## ADDENDUM No. 1

Date: February 6, 2025  
To: Prospective Bidders  
From: Napa Valley Transportation Authority (NVTA)  
Re: Addendum No. 1 to IFB No. 25-R17 – INSTALLATION OF OWNER  
FURNISHED BUS SHELTERS

1. ADD to Attachment D: Special Conditions, Section 3-2.02 PCC 4" SIDEWALK:

CHECKED BY:	IHH
APPROVED BY:	JBL
DRAWING NO.	S-4

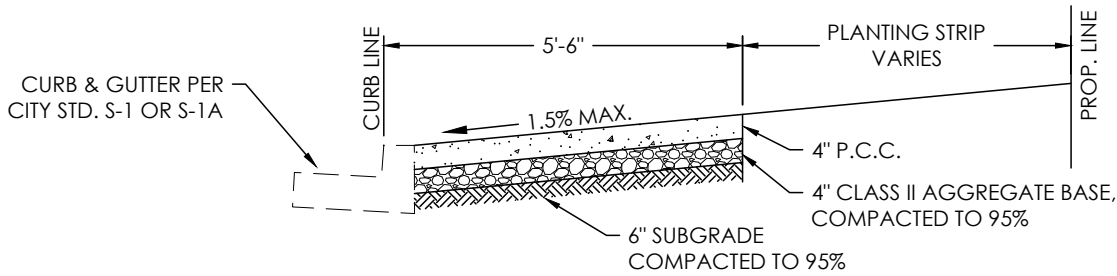
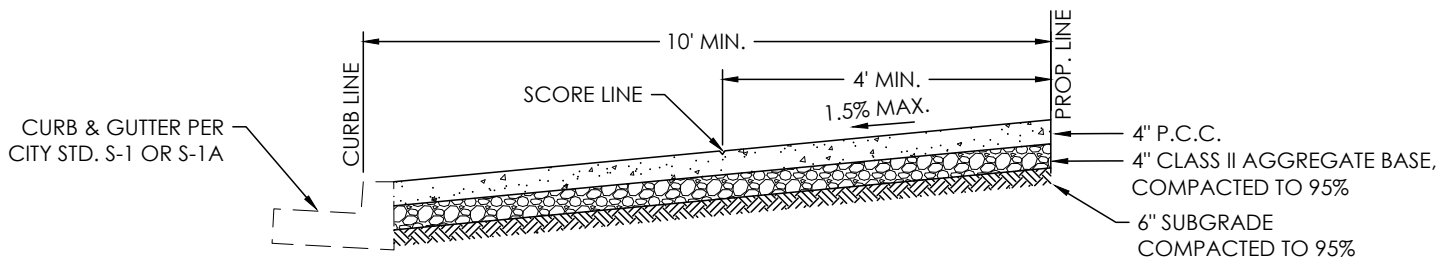
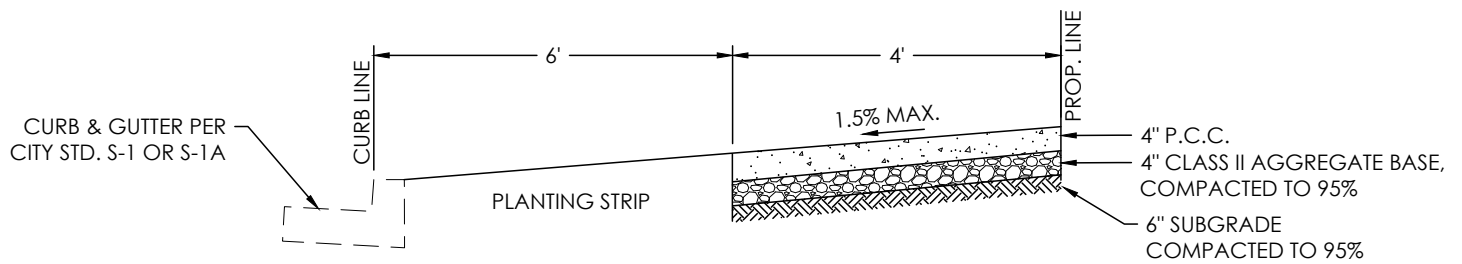
*Para 2: "Prior to placement of 4" sidewalk, the contractor shall be responsible for independently contracting with a certified and reputable materials testing firm to schedule material testing and confirm subgrade and base material sections are compacted to a minimum 95% relative compaction per City of Napa Standard Detail Drawing S-4. Contractor shall provide material test results upon request."*
